**ELKHART HISTORIC & CULTURAL PRESERVATION COMMISSION
FEBRUARY 27, 2025**

- 1) CALL TO ORDER
- 2) ROLL CALL
- 3) APPROVAL OF AGENDA
- 4) APPROVAL OF MINUTES - DECEMBER 30, 2024
- 5) HEARING OF VISITORS
- 6) OLD BUSINESS
 - A. NEIGHBORHOOD UPDATE/PROGRESS REVIEW/NOMINATIONS
- 7) NEW BUSINESS
 - A. 25-COA-01 142 STATE STREET - WINDOWS
- 8) ANNOUNCEMENTS
- 9) ADJOURNMENT

Elkhart Historic & Cultural Preservation Commission
CERTIFICATE OF APPROPRIATENESS
Community Preservation Specialist - Staff Review

Application Number: 25-COA-01

142 State – November 2024 – front façade

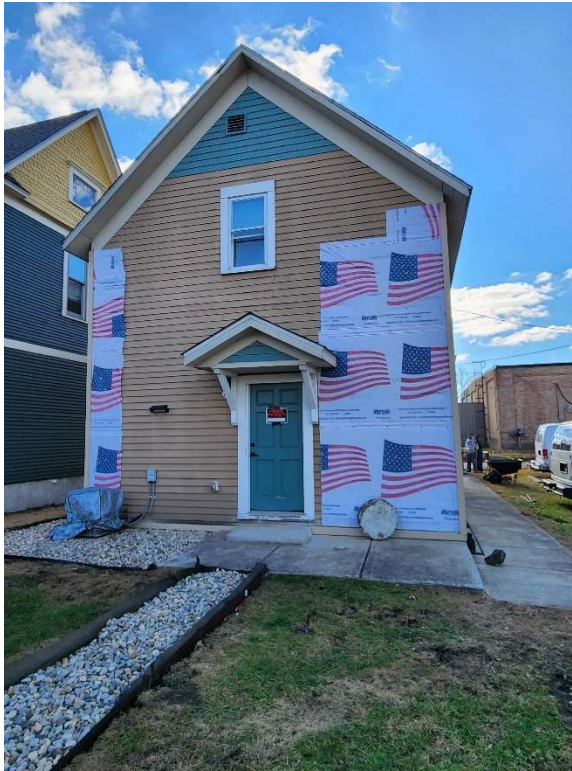
Linley said that looking at the picture that was provided from November 2024 front façade; you got a cute little window up at the top, the color changes at the top, the cool curve at the top of the window, then the fancy front window and those really sad round columns. Linley said that it is an adorable house and it would be wonderful when he gets it done but she questioned what they will do at this point. Whitmer had another question for Parcell in one of her recommendation to discuss it. Whitmer referred to one of Parcell's recommendations about the windows on the west side of the house. Parcell said that those windows are the most visible from the street. Whitmer asked if those are the most important to retained. Parcell responded yes, exactly because that's the city ordinance as well as the state ordinance tells the board as a commission need to review what is visible from the public way. Parcell explained that is hard to see the east side and obviously you cannot see the backside from anywhere but the east side especially because it is a one way street and it is pretty close to the house that LaCasa just finished which makes the east side minimally visible from the street but the west side and south side are very visible that's why those are the two that are really important. Whitmer asked something that was inaudible. Parcell responded yes that's is correct.

1. Windows were purchased in September 2024.
2. As part of COA 24-COA-07 the request to replace existing windows with vinyl windows was denied by the HPC at their December 30, 2024 meeting as stated in the decision letter:
“Windows - denial of the request for replacement with vinyl windows. The existing windows should be repaired and retained where possible. The lead paint will be encapsulated or removed at a minimum for the street facing windows. The west façade windows should be retained. The windows not public facing (east and north) can be replaced with other material as needed. A storm window be used to retain the multi pane look also for the transom window above the door. The new windows not be vinyl rather a fiberglass or aluminum clad maintaining the original proportions, two over two (2/2). New windows shall have applied grid spacers to the glass not between the glass. The curved detail over the windows shall also be retained. Approved 5-0”

The fact the owner did not disclose windows had already been purchased on 24-COA-07 application does not materially change the recommendation for denial, as the purchased windows do not meet the guidelines in material or design.

East Façade – 2024

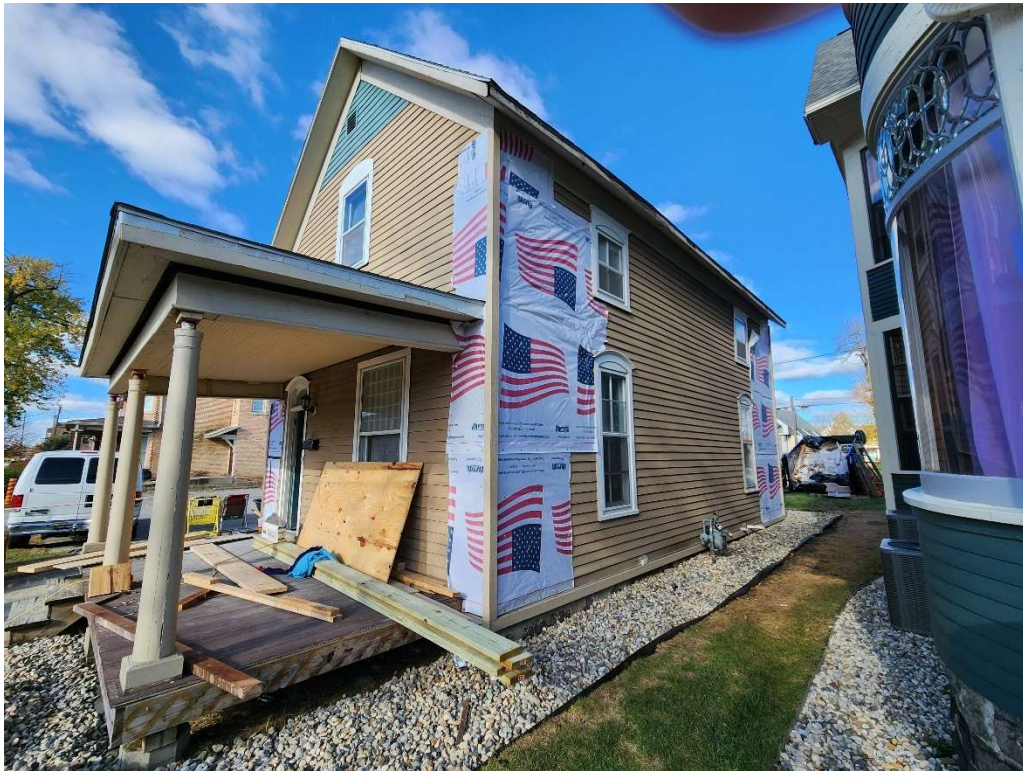
Linley asked Parcell if the current windows are two over two. Parcell responded that some of them are. Linley added that nothing mostly one over one. Parcell told Linley to look at the picture of the east façade which are two over two but she was not able to say that all of them were the same way. A question was asked but it was inaudible. Parcell responded undoubtedly there is probably various kinds. Parcell said that the most defining features definitely is a two over two probably is the original window and keeping that where it is and looking at the side view those curved areas above the windows, that trim is very distinctive, not what's in the front, that upper window above the porch that's somebody failed attempt at mimicking what's on the side and that is not an original thing. Parcell referred back at the earlier photos in 2003 there was nothing above that window and somebody created something that does not look cool. Whitmer added as a contractor you can create something better to match the size. Parcell said something to look like it's there and added that's a very distinctive feature and also very visible because it is in the west side. Linley said that it is very cool. Parcell said that they did the same thing above the front doors which has the same thing above the transom and that's a very distinctive which makes it really attractive. Linley said that they cannot see it clearly in the pictures but Parcell mentioned that the front window that is protected by the porch has a very elaborated top piece to it. Parcell said yes and added that there are a lot of little divisions to it. Linley asked if there was hope of saving that. Parcell responded that she hoped that the front window could be save. Whitmer added that it has been protected from the elements and it should be in better conditions. Linley asked if there was something they could do something to protect it and save it. Jones responded that it is a single pane window and as far
